October 23, 1954

Ask MRS. BLISS -

ARBOR -

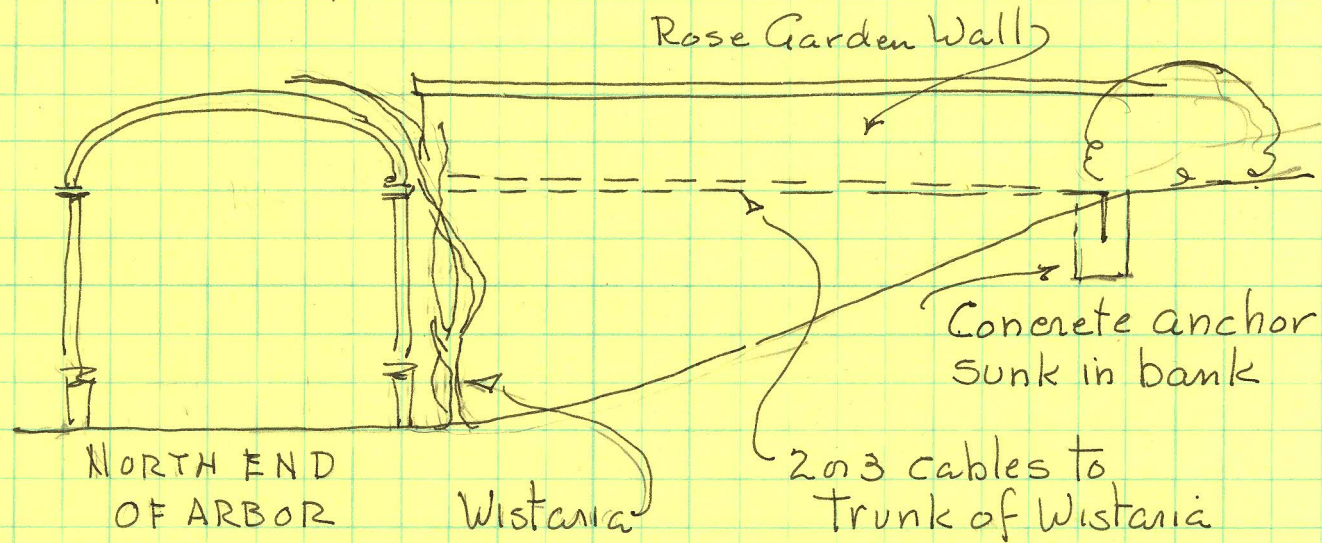
Contract would be based on enclosed measured
drawings of existing arbor

with the South Elevation changed to
match the North Elevation - ?

add a wood seat built into the arch
of the South Elevation - ?

Arbor plan also indicates how concrete
balustrade would meet wood arbor -
